# CITY OF PORTLAND BUILDING PERMIT

Job ID: 2012-07-4419-ALTCOMM

has permission to Renovate interior office on 5th Floor

**Benjamin Wallace - RE: 178 Middle St FLR 5 permit 2012-07-4419-ALTCOMM**

178 Middle St.  
5th Floor

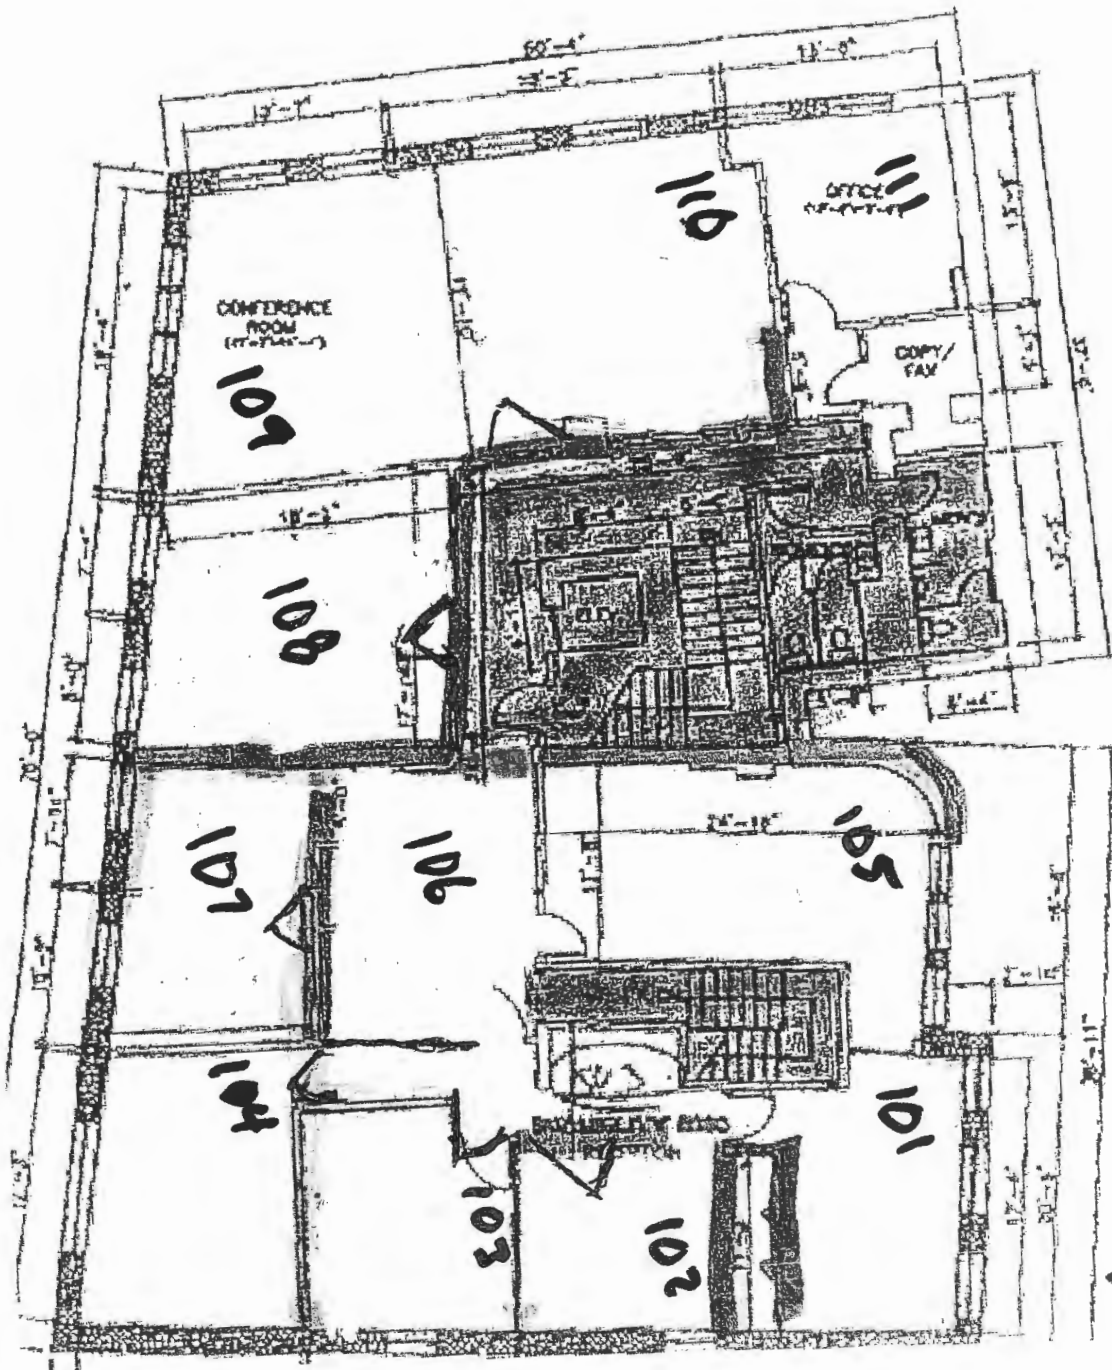
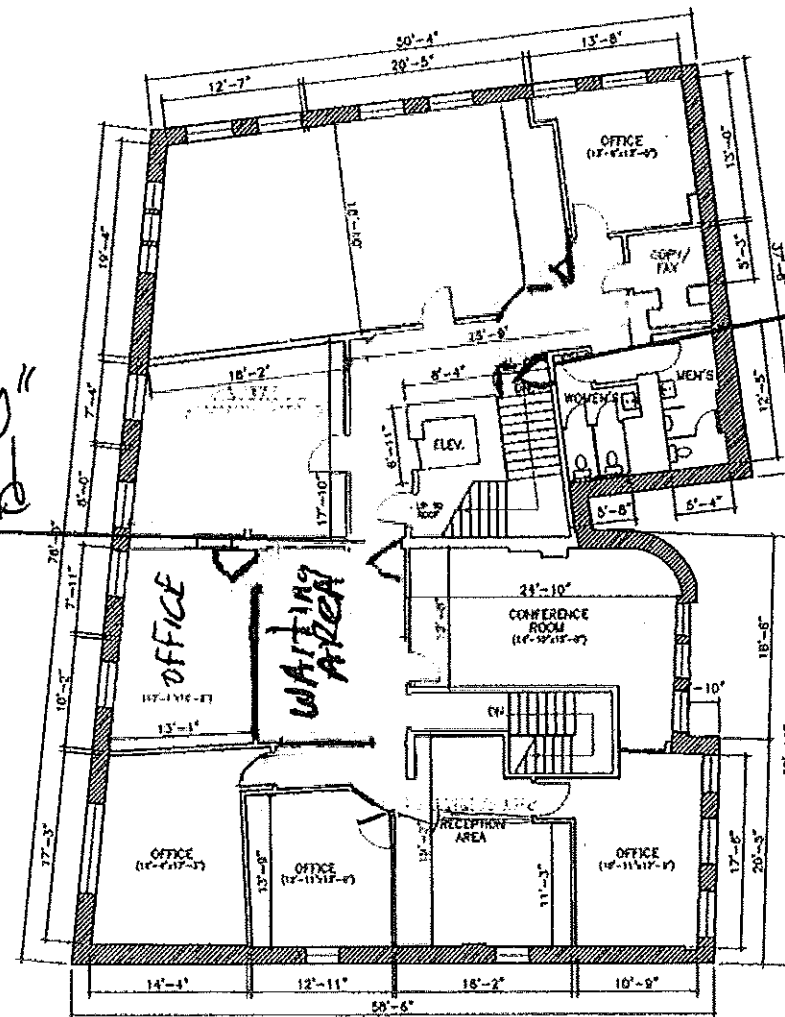
- Updated the permit for the 5th floor showing enclosure of the top of the stairs with the necessary landings on both sides of the fire door, and include removing the door that separates the stair down from the 5th floor at the 4th floor landing, and installing the new fire door to separate the 4th floor landing from the corridor. Please submit scalable plans.

I just printed off a copy for the permit. The enclosure of the stair will have to be 1-hour rated construction with a 1-hour rated fire door assembly. Please send along the detail on the wall and the ceiling assemblies you'll be using to achieve 1-hour fire resistance at the top of the stair with the UL number. If you're not sure where to find this you can look up the Fire Resistance Design Manual put out by the Gypsum Association on the internet. It's free to download. If that doesn't work for you we have a copy here in the office you're welcome to browse and make select copies of.

Ben, Attached above is the scaled floor plan that you asked for showing the modifications, thanks for your site visit today. Dan

Drawing Title: Boyd Block  
176-188 Middle St.  
4th & 5th Floor Plan  
Portland, Maine

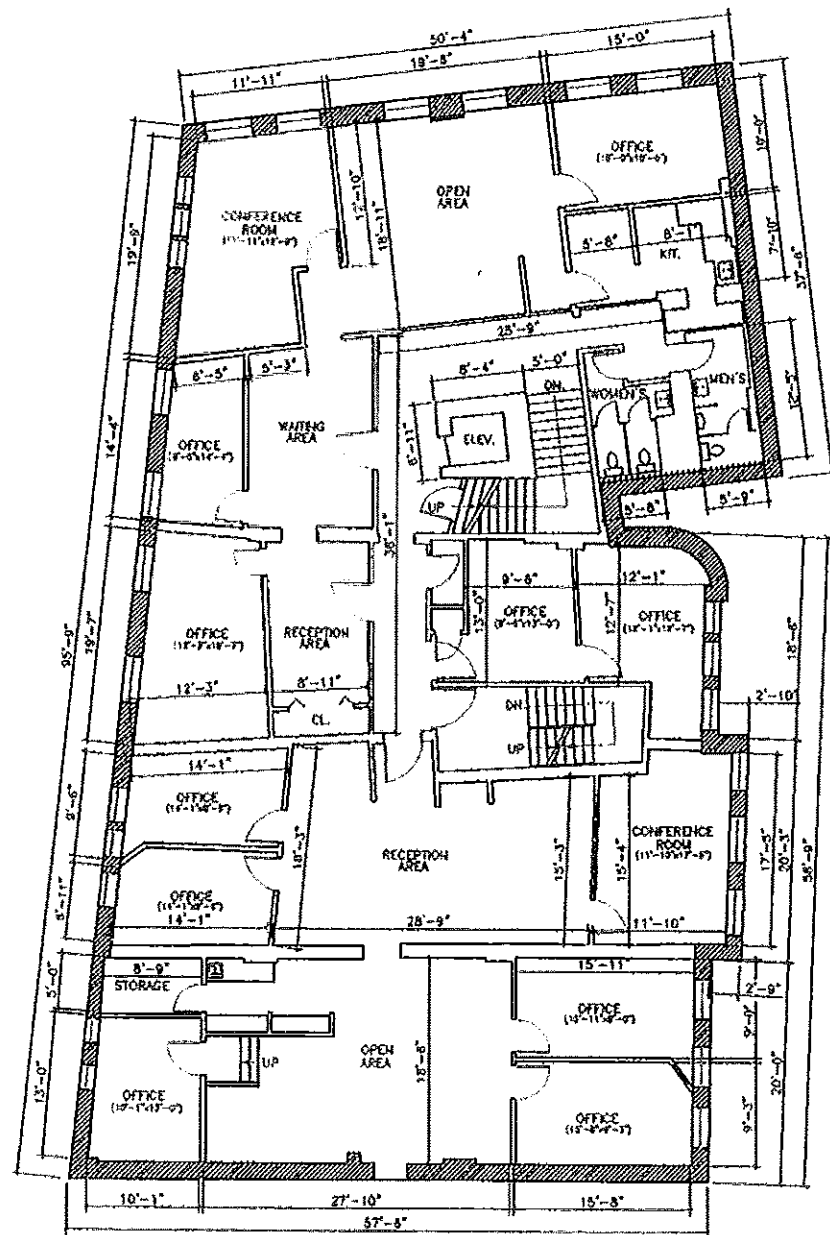
1. The stair identification signage shall be located within the stair enclosure at each floor landing and visible when the door is in the open or closed position.

2. The door from Unit 4-2 directly into stair A needs to swing into the stair enclosure. As you approach to leave the hinges should be on the left and the lever on the right.

3. You may want to post signs on the doors into Stair B that state "EMERGENCY EXIT ONLY" since the doors don't provide re-entry onto the floor once you enter and the stair discharges into the back alley.

4. All door assemblies into the exits must be 1-hour fire rated. Existing doors will require inspection by a certified or approved door inspector. Chuck Noble is the only one I know of around here but there may be others. His number is 490-2500.

5. I need to know if you determined if the entire building is sprinklered and if not is the ground floor sprinklered throughout?
6. I'm not reviewing design of the fire alarm system as a part of this. That is a separate review.
